**REMARKS****Drawing Objection**

**Prior Art Rejections****A. Overview**

Fig. 4

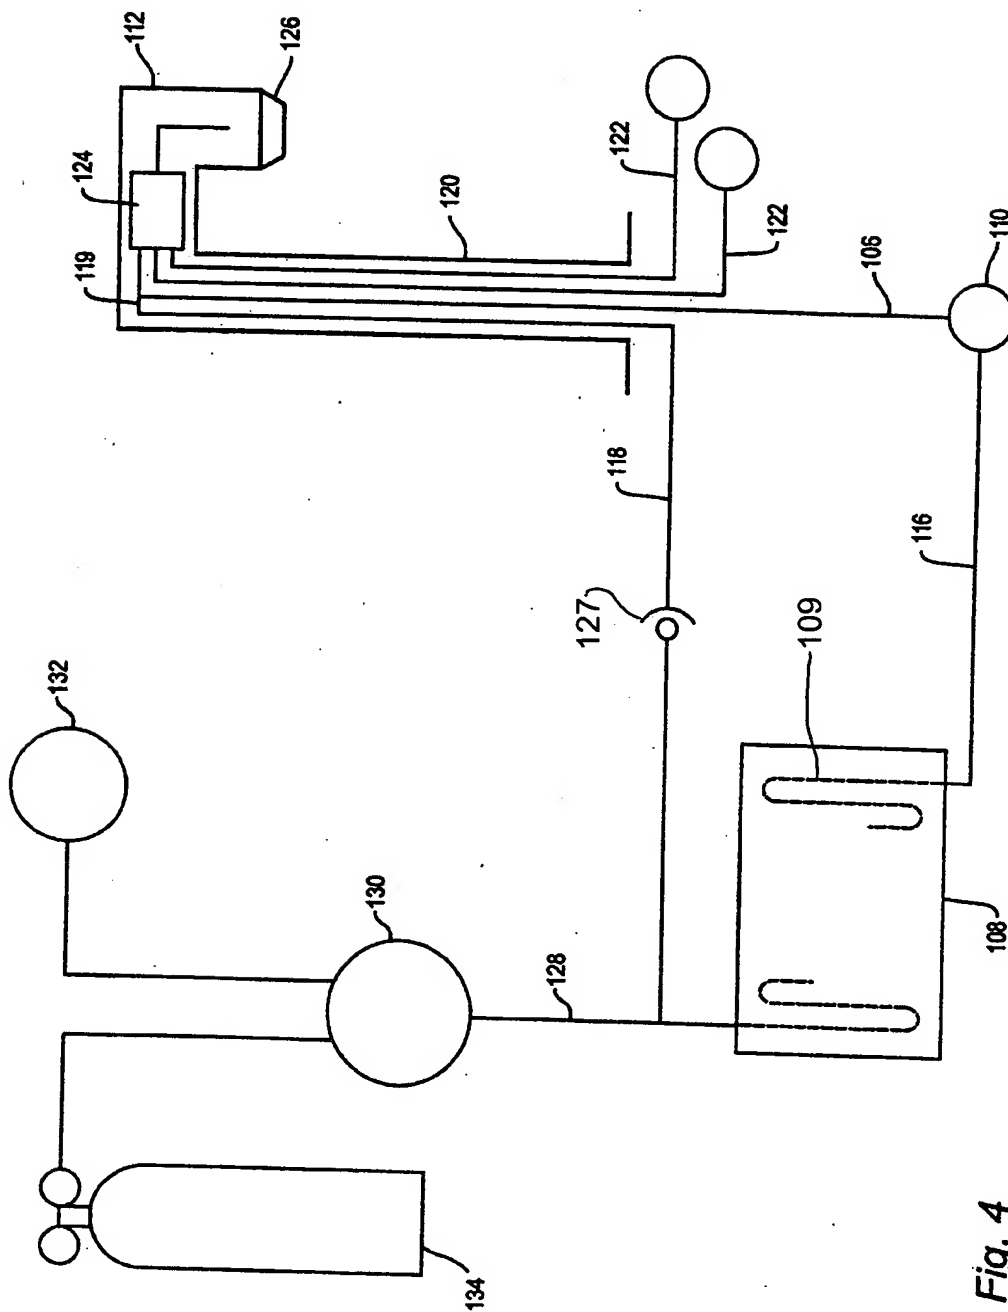
In the Official Action of October 19, 2004, the drawings were objected to under 37 CFR 1.83(a). This objection is based on claim 10 of the application which calls for the carbonator to be in the carbonated water circulation circuit between the circulation pump and the heat transfer coils. To provide clarification, Figures 4 and 6 have been amended through the addition of reference numeral 127 specifically directed to the check valve. The phrase "check valve 127" was presented in the original specification in numbered paragraph [0051]. Thus, the recitations of claim 10 are more clearly established in Figures 4 and 6 with the addition of the reference number. A duplication of numbers has been corrected through changes in Specification paragraph [0050] and the addition of reference number 125 to the drawings. Reconsideration of the objection and acceptance of the proposed drawing changes to Figures 4 and 6, attached hereto with changes in red, is requested.
